REVIEW OF DRAFT
ON
"FIRE-RESISTIVE STANDARDS FOR MATERIALS OF CONSTRUCTION"

September 30, 1969

I. Benjamin, L. Issen and H. Shoub

State of Wisconsin
Department of Industry, Labor, & Human Relations

FIGURE 1.

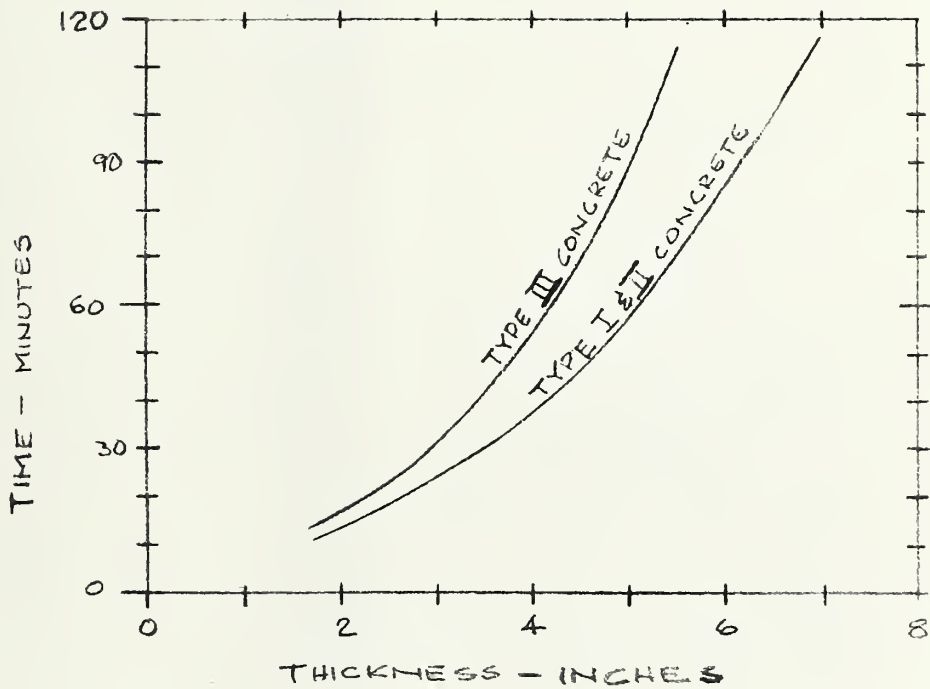
We have prepared figure 1 of this report to give some idea of the critical time for the evacuation of a floor which would be subject to a fire exposure. We have picked 180 °F as a limiting temperature--to represent the maximum temperature that could exist on a floor surface and yet allow a person to rapidly pass over for evacuation. From the figure, a floor 3-1/2-inches thick of Type I concrete, would allow an evacuation time of about 25 minutes before the floor gets too hot to step over in the local area where the direct fire exposure has occurred.
